Modification Recommended Service Note

P5007B Keysight Streamline Vector Network Analyzer

Serial Numbers: From MY61100009 to MY61100135

Potential lifted front panel overlay

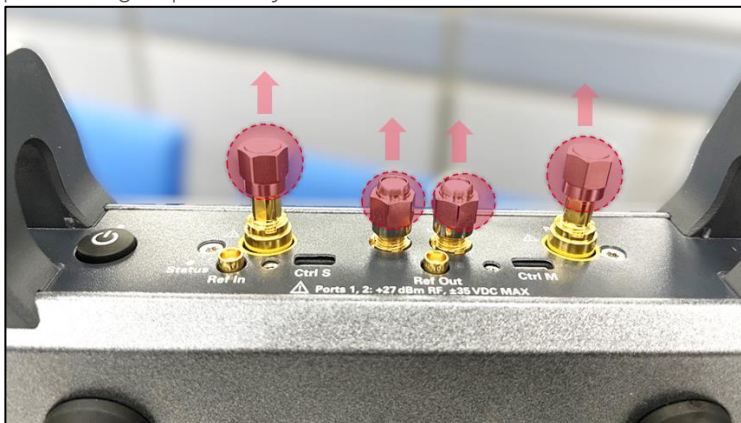
Keysight streamline series vector network analyzer (VNA) of serial number range identified in service note cover page might potentially exhibit the following lifted front panel overlay symptom.

Apart from cosmetic imperfections, the lifted front overlay could have led to non-fully attached *Ctrl S* micro-HDMI cable connector in multi-VNAs setup configuration.

-> Apply this service note only if end users' VNA is exhibiting the following symptom.

Procedure to replace the front panel overlay.

1. Remove the front handles. Detach the 50-ohm termination (LO-In, LO-Out, Port 1 & Port 2) or protecting caps if they are attached to the VNA.

2. Pry open the existing front panel overlay and remove it from front panel.
3. Clean the metal surface thoroughly and ensure it is free of adhesive residue.
4. Affix the new self-adhesive front panel overlay onto the metal surface.
5. Reinstall (reuse) the 50-ohm terminations and port protecting caps accordingly.

6. Reinstall (reuse) the front handles.
